# GUNNAMATTA PARK MASTERPLAN REPORT

Prepared for Sutherland Shire Council,  
April 2010

GUNNAMATTA BAY PARK MASTERPLAN PROPOSED UPGRADE WORKS  
Review of access provisions for people with a disability

### Entry Ramp- Option 2

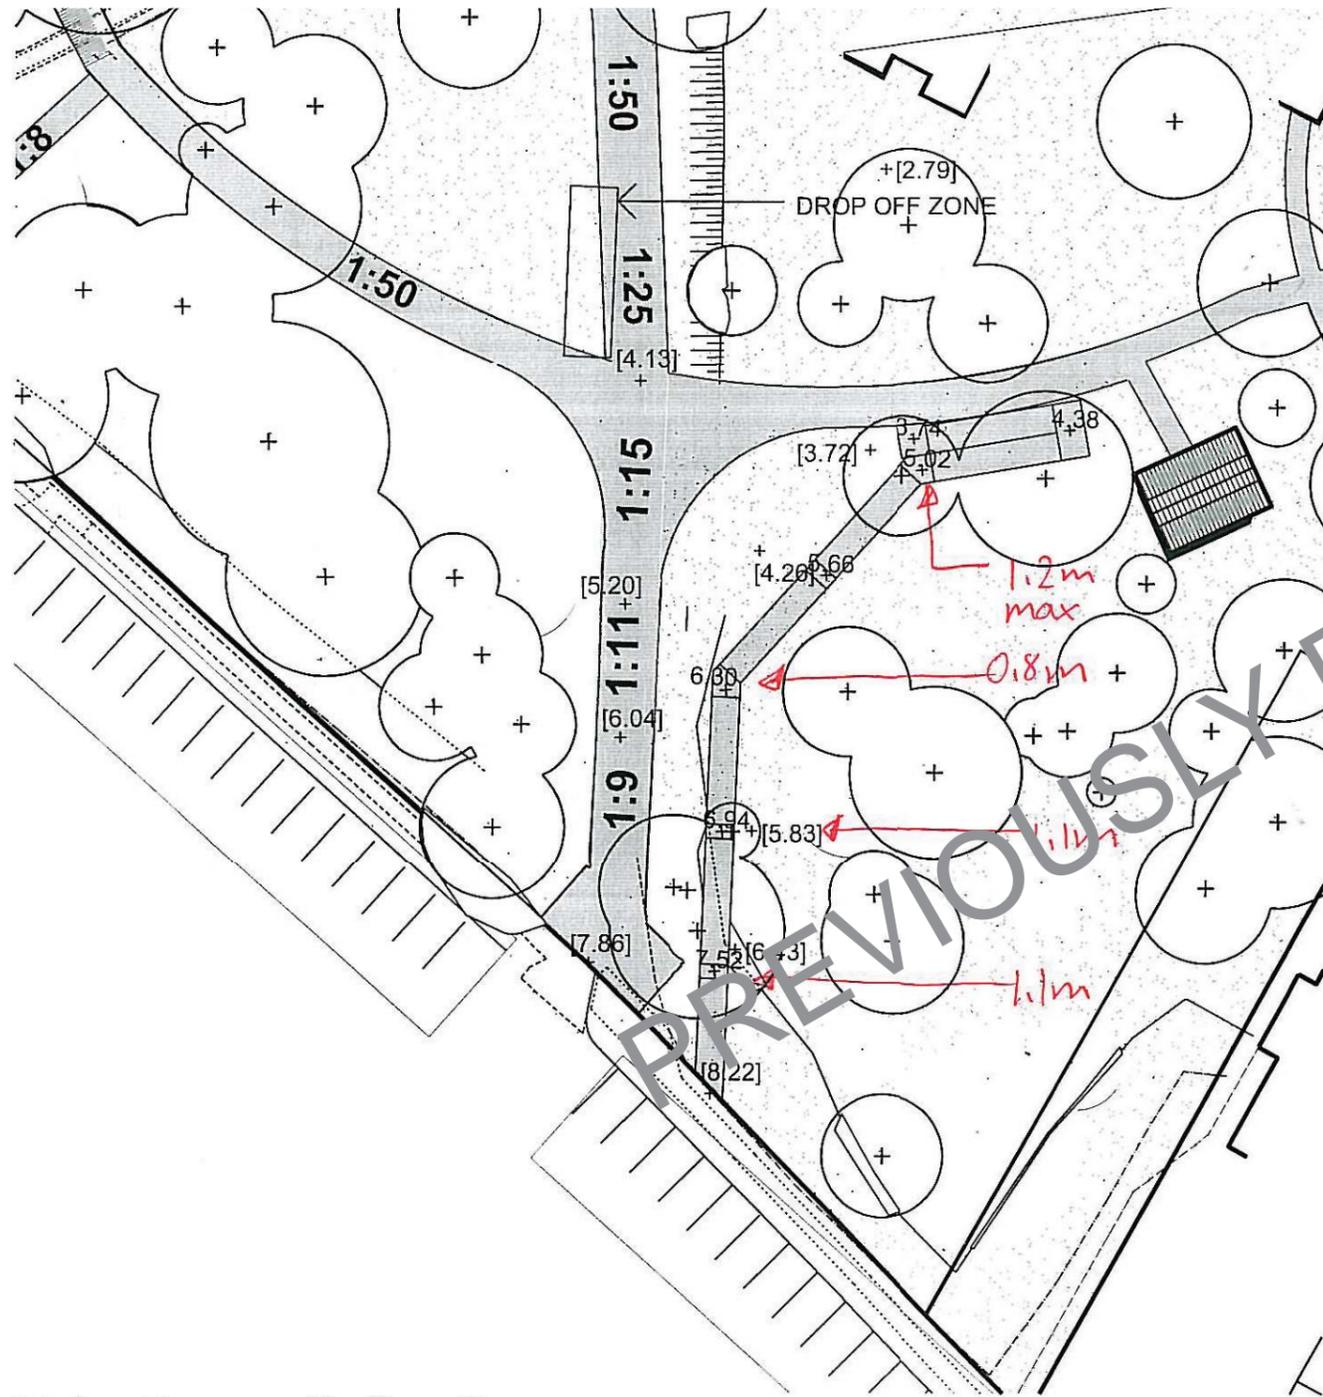
Entry Ramp - Option 2 provides an accessible pedestrian entry ramp to the park which meets the intent of the DDA and links the external footpath to a convenient area of the park which is located on an accessible path of travel to the adjacent accessible facilities. In our opinion this option is preferable to Options 1, 3 and 5.

The drop off zone proposed in Option 2 is similarly well located for general access to the park and the accessible internal paths and facilities proposed.

We recommend Option 2 is provided as a main park entry.

### Alternative Entry - Option 4

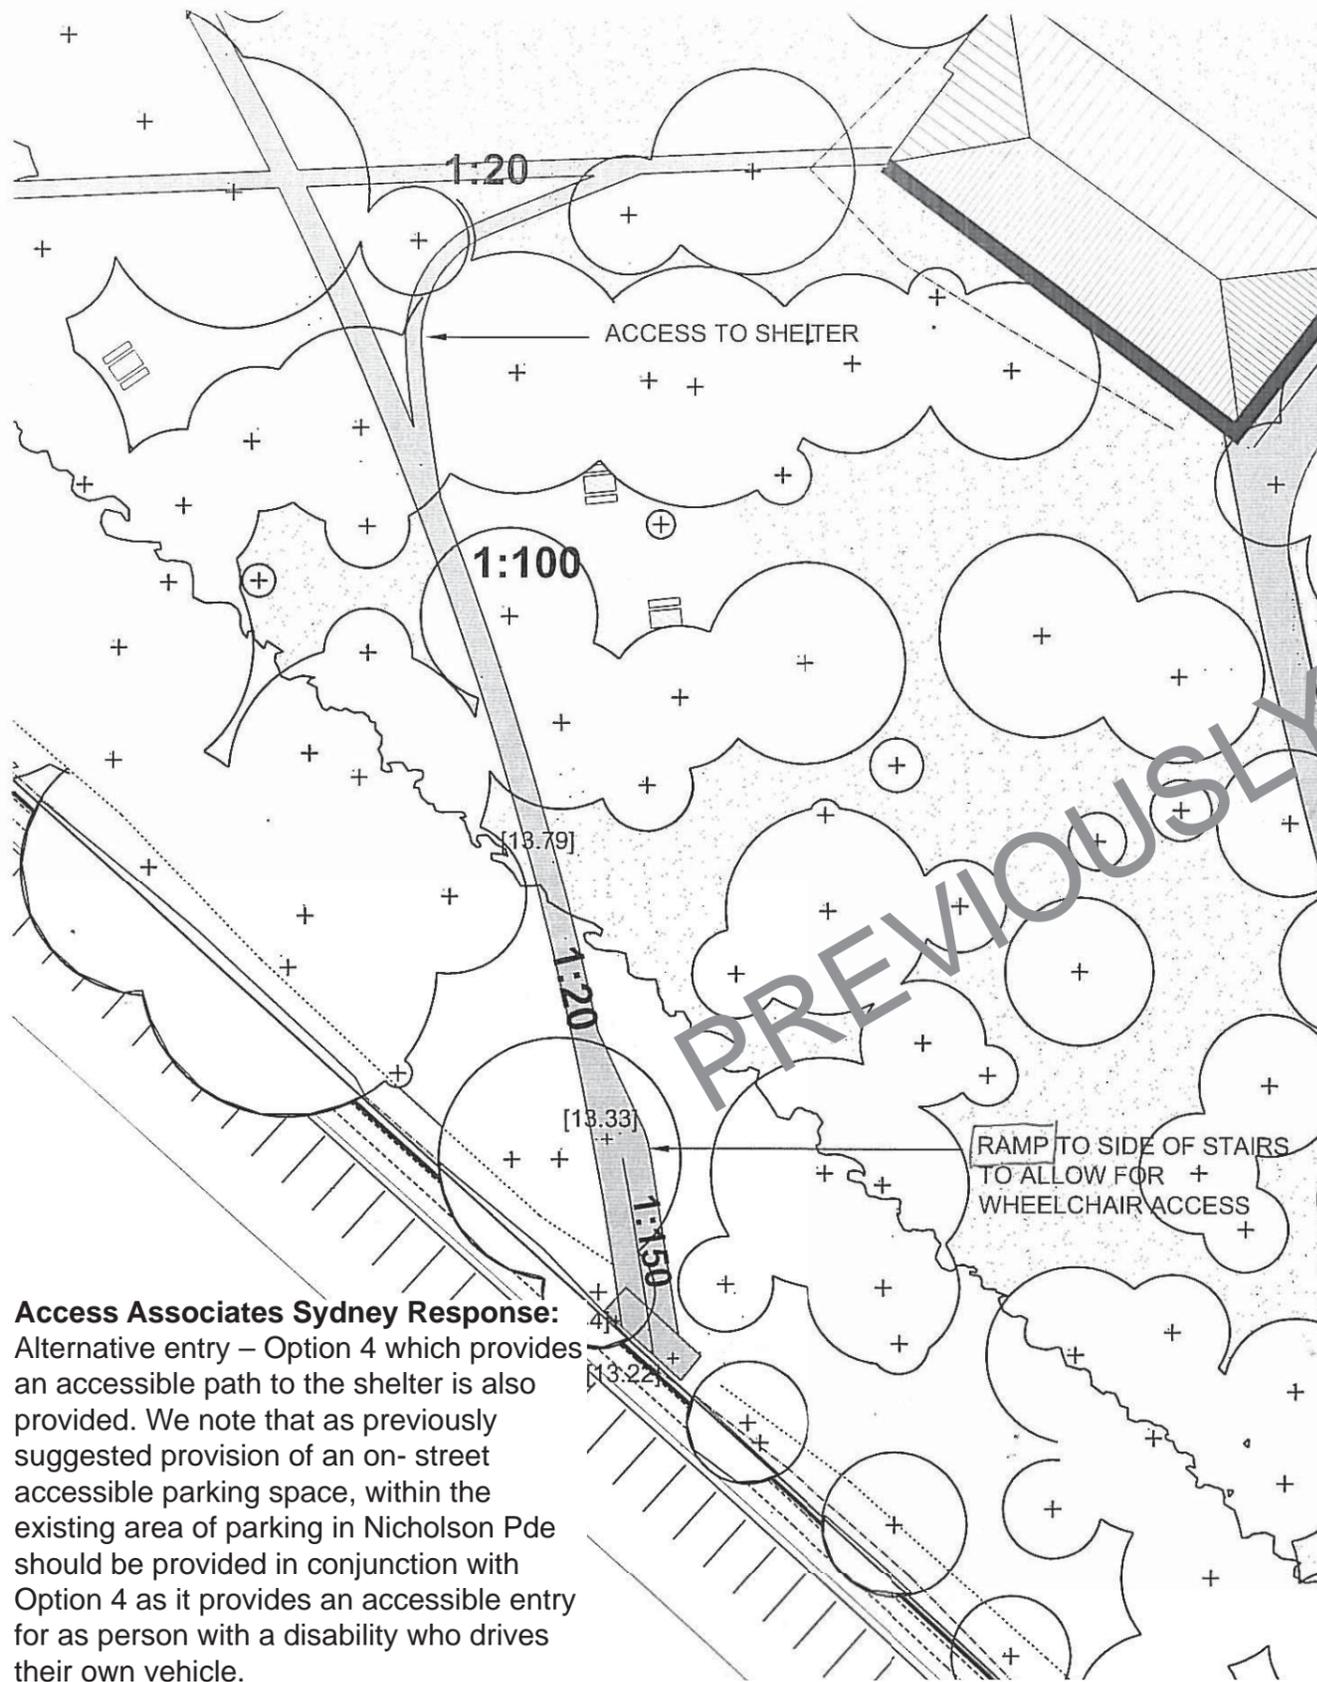
**Access Associates Sydney Response:**  
 Alternative entry – Option 4 which provides an accessible path to the shelter is also provided. We note that as previously suggested provision of an on- street accessible parking space, within the existing area of parking in Nicholson Pde should be provided in conjunction with Option 4 as it provides an accessible entry for as person with a disability who drives their own vehicle.

### Alternative Entry - Option 5

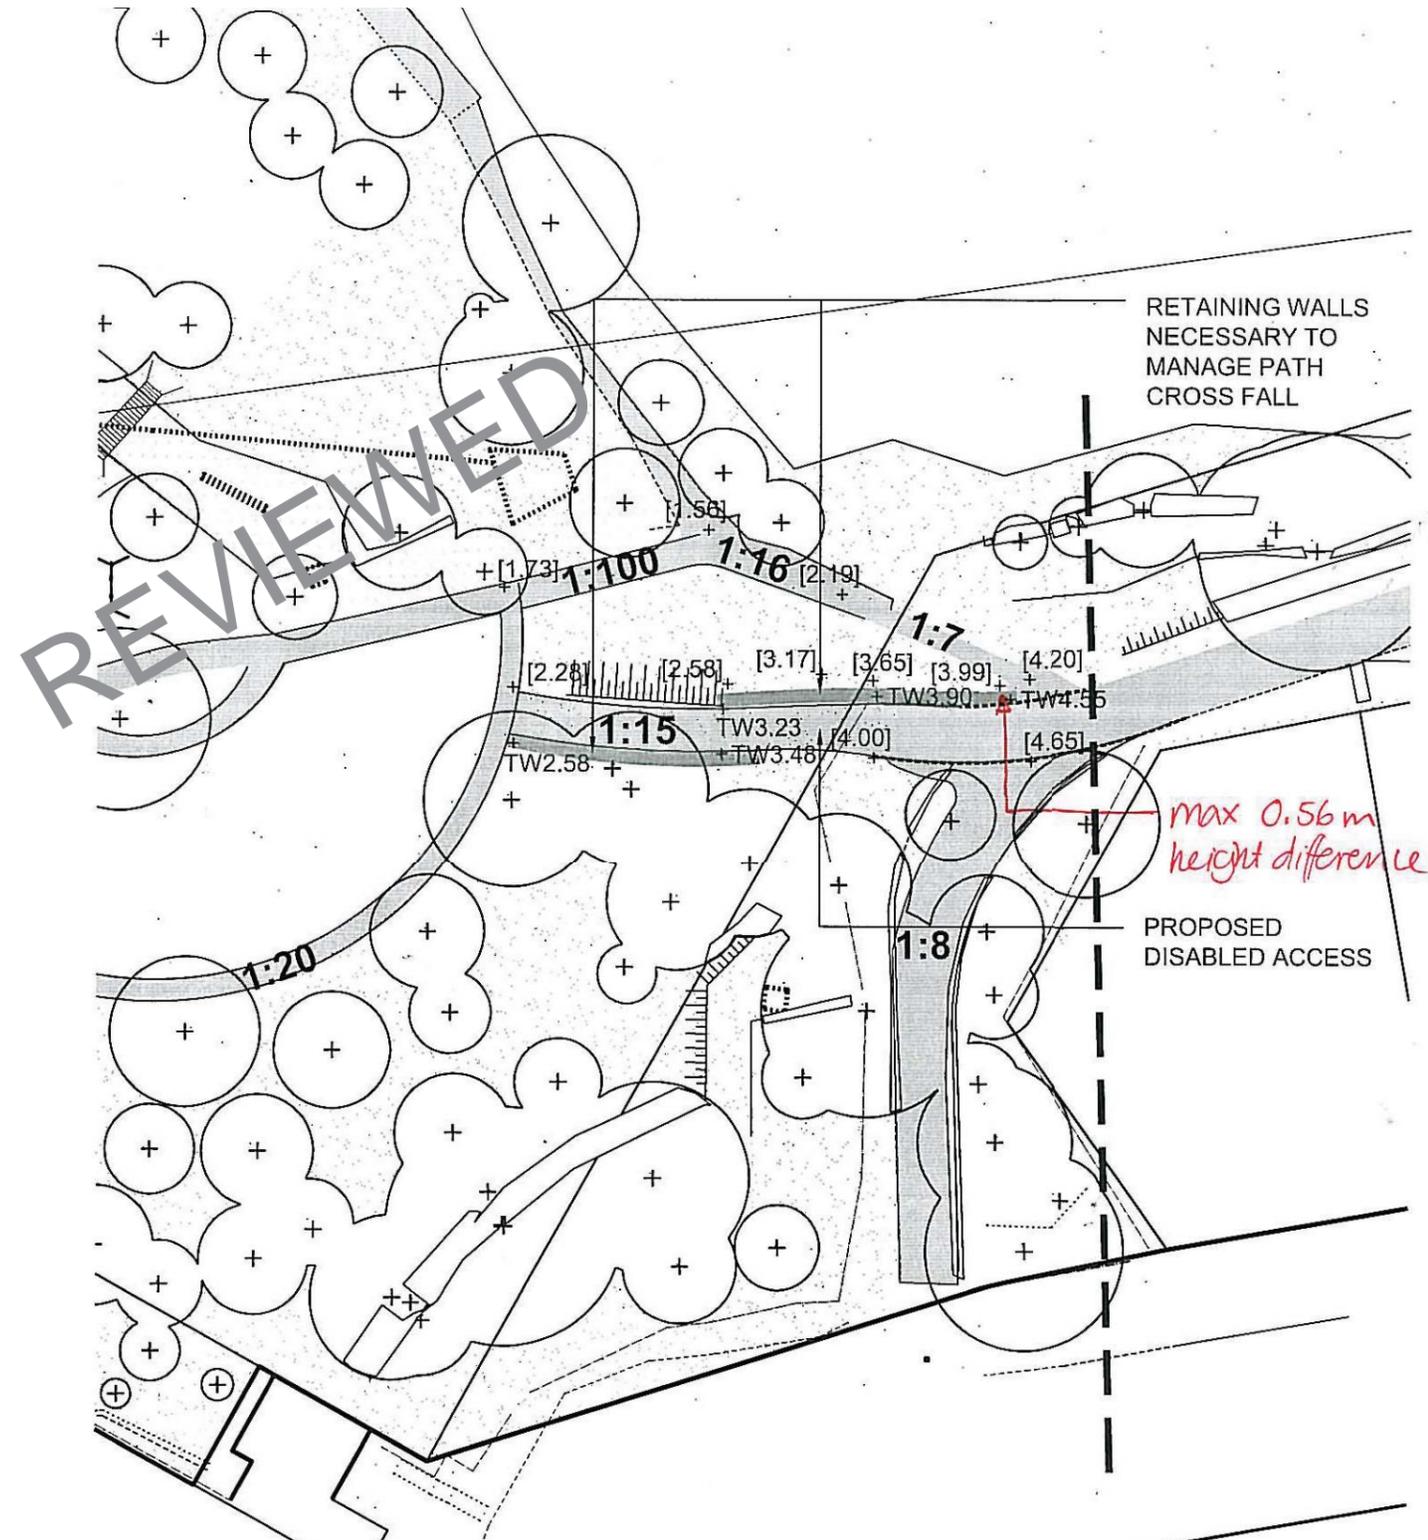
**Access Associates Sydney Response:**  
 Option 5 does not provide a main entry to meet the intent of the DDA – it could provide an additional accessible link if desired.
